Access Compliance Report Public Rights-of-Way (Curb Ramps)

Main Street: N_RANCHO_SANTIAGO_BLVD		Cross Street: E_SYCAMORE_AVE		Location:	NE
ADA ID: RPAT210928085400	Ramp Type:Type 1 - Perpendicular Diagonal Initial Pass/Fail: Fail		Overall Compliance: No	Severity Score:	35
Codes/Mitigation Info/Possible Solution			Field Measurements/Component Compliance

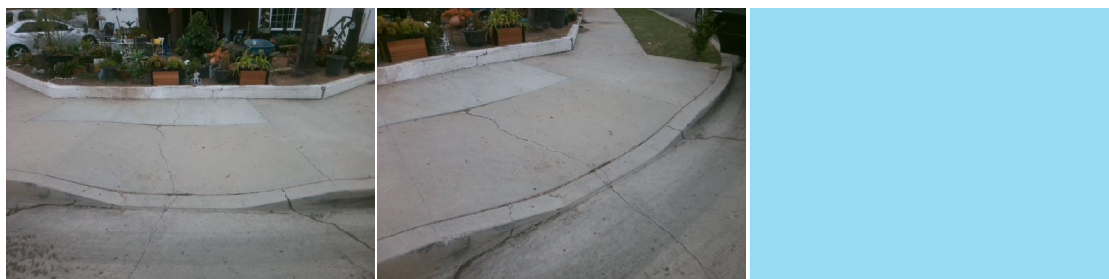
R304.2.2, R204.3, R304.5.1, R304.5.3, R302.7, STD 1115

Compliance	Description	Data	Compliance	Description	Data
N/A	Ramp Length (in)	69	N/A	Flare Type LT	
No	Ramp Width (in)	45			N/A
No	Ramp Run Slope (%)	10.2	N/A	Flare Slope LT (%)	N/A
No	Ramp Cross Slope (%)	2.2	N/A	Flare Traversable LT	N/A
N/A	Landing Present	N/A	N/A	Flare Type RT	
N/A	Landing Length (in)	N/A			N/A
N/A	Landing Width (in)	N/A	N/A	Flare Slope RT (%)	N/A
N/A	Landing Run Slope (%)	N/A	N/A	Flare Traversable RT	N/A
N/A	Landing Cross Slope (%)	N/A	N/A	DWS Provided	N/A
N/A	Landing Movement Obstructed?	N/A	N/A	DWS Contrast	N/A
	Landing Movement Type	N/A	N/A	DWS Length (in)	N/A
N/A	Landing Shared	N/A	N/A	DWS Full Width	N/A
N/A	Clear Space	Yes	N/A	DWS Offset Left (in)	N/A
N/A	Clear Space To Crosswalk (in)	N/A	N/A	DWS Offset Right (in)	N/A
N/A	Marked Crosswalk 1	No	N/A	Marked Crosswalk 2	No
	Crossing 1 Direction	W		Crossing 2 Direction	S
	Marked Crosswalk 1 Width (in)	N/A		Marked Crosswalk 2 Width (in)	N/A

N/A	Ramp Inside Crosswalk 1	N/A	Yes	Ramp Inside Crosswalk 2	N/A
	Crossing 1 Slope (%)	5.8		Crossing 2 Slope (%)	1.5
	Crossing 1 Cross Slope (%)	0.5		Crossing 2 Cross Slope (%)	0.5
N/A	Gutter Ponding	N/A	No	Curb Slope	10.1
Yes	Gutter Lip Height (in)	0		Road Run Slope (%)	2.6
N/A	Gutter Run Slope (%)	N/A		Road Cross Slope (%)	0.7
N/A	Gutter Cross Slope (%)	N/A			
No	Overall Surface Condition:	Poor	No	Perp Joint Present	No
	Cross Gutter Present?	Yes		Spandrel Present?	Yes
	Replace Cross Gutter?	No		Replace Spandrel?	No

Remove & Replace Curb Ramp With Two New Directional Ramps or Equivalent.
